02/06/2013 For the record. The purpose of this post in the Garwin Archive is to document, not to justify, my initial criticism of the National Research Council BMD Committee Report, “Making Sense of Missile Defense.” My post of 10/01/2012 was provoked by comments from the House Armed Services Committee that the Report justified the HASC’s judgment of the urgent need for an East Coast missile defense site.

On 10/01/2012 I posted in the Garwin Archive the item, “Comments by Richard L. Garwin, October 1, 2012, Re: the National Academies of Science Report, ‘Making Sense of Ballistic Missile Defense...’”, which see<sup>1</sup>. This had been provided to the authoring Committee (the “BMD Committee”) on 09/20/2012.

*"Figure 2 below<sup>2</sup> shows a polar plot of the radar cross section of a flatback cone that has a thin X-band radar absorbing layer that produces a reflection reduction of roughly 10.*

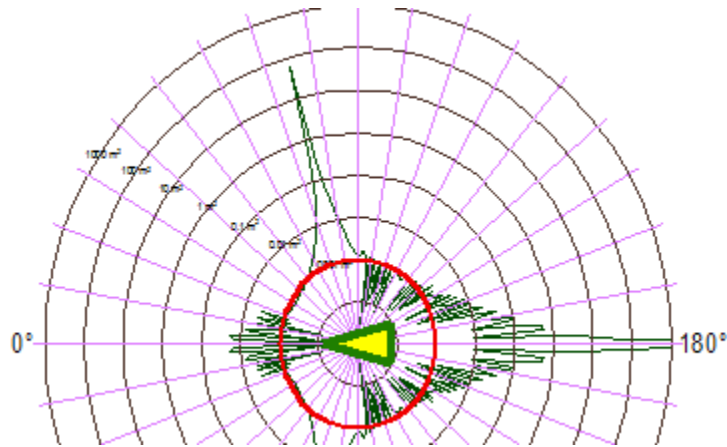
Finally, in this comment, I note that the question of warhead cross-section is handled only by reference to "cross-sections provided by the government." The Report also indicates that it would be "difficult" to maintain low cross-section over the broad angular range of view posed by multiple GBX observing the same threat cloud. Long-range rocketry is full of difficulty and that posed by an orientable RV is quite separable.

*The cone has a half angle of 15°, a base diameter of 1.5 meters, and a length of 2.9 meters. The 0.001 m<sup>2</sup> radar cross section values are shown by the red circle. The next*

*outer circle shows the locus of 0.01 m<sup>2</sup> values of the radar cross section. As can be seen from the figure, the range of angles over which the radar cross section from the specular reflection off the cone rises above 0.001 m<sup>2</sup> over an angular range of roughly 30°. The specular reflection rises above 0.01 m<sup>2</sup> over a range of only 10°. The reflections off the back of the cone are over similar angular ranges.”*

Of course, a designer hoping to take advantage of these relatively low cross-sections would insist on actual measurements that could conveniently be conducted either in an indoor gymnasium or an outdoor range, taking advantage of short-pulse lengths at x-band in order to avoid reflections from nearby objects or structures.
